FCC Class II Permissive Change Request Letter

RE: FCC Permissive II Change Request for Company: Guangdong Hisense Broadband Technology Co., Ltd. FCC ID: 2AGHCHBMT04

Model: 6401

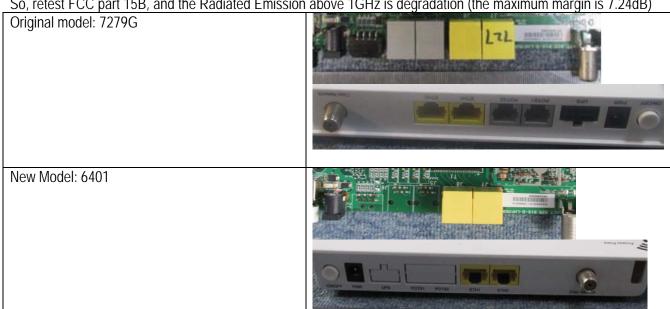
HW deletes 2POTS ports: RJ11 port x2+CATV Port (compare with original model 7279G), No influence RF

character

So, retest FCC part 15B, and the Radiated Emission above 1GHz is degradation (the maximum margin is 7.24dB)
